RIVERVIEW POINTE SUBDIVISION, RESUBDIVISION OF LOT C OF THE RESUBDIVISION OF LOT 2

APPLICATION NUMBER 23 DATE June 5, 2003
APPLICANT Riverview Pointe Subdivision, Resubdivision of Lot C of the
Resubdivision of Lot 2
REQUEST Subdivision

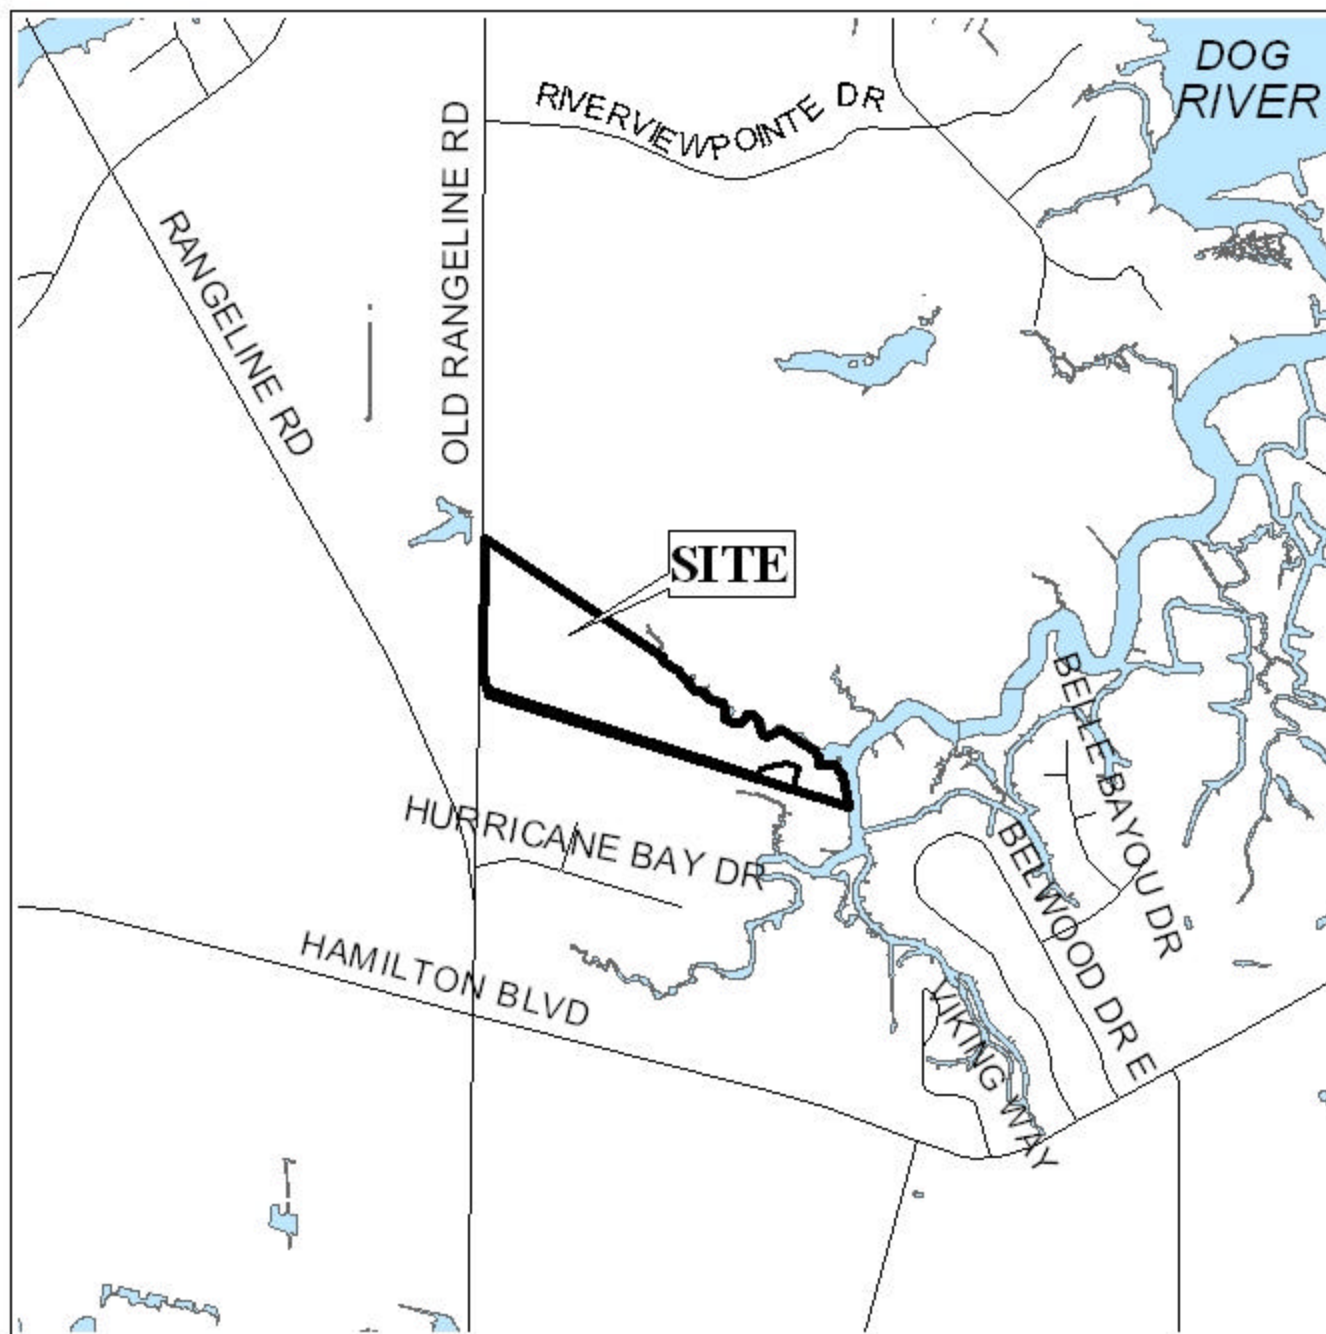
As illustrated on the plat, Lot C-1 would have 1,050' of frontage along Old Rangeline Road, access management is a concern. Therefore, the placement of a note on the final plat stating that Lot C-1 should be limited to two curb cuts to Old Rangeline Road, with the size, location and design to be approved by County Engineering, should be required.

As proposed, Lot C-2 would exceed the width to depth ratio, therefore a waiver of Section V.D.3 would be required.

As illustrated on the Vicinity Map, the site contains wetlands, thus this area could be considered environmentally sensitive; therefore, the developer must obtain any necessary federal, state, and local environmental approvals.

This site is located in the County, thus a note should be placed on the final plat stating that any lots which are developed commercially and adjoin residentially developed property must provide a buffer in compliance with Section V.A.7., of the Subdivision Regulations.

With a waiver of Section V.D.3, the plat meets the minimum requirements of the Subdivision Regulations and is recommended for Tentative Approval subject to the following conditions: 1) the placement of a note on the final plat stating that Lot C-1 is limited to two curb cuts to Old Rangeline Road, with the size, location and design to be approved by County Engineering; 2) the placement of a note on the final plat stating that the developer obtain any necessary approvals from federal, state, and local agencies; and 3) the placement of a note on the final plat stating that any property that is developed commercially, and adjoins residential property will, provide a buffer in compliance with Section V.A.7. of the Subdivision Regulations.
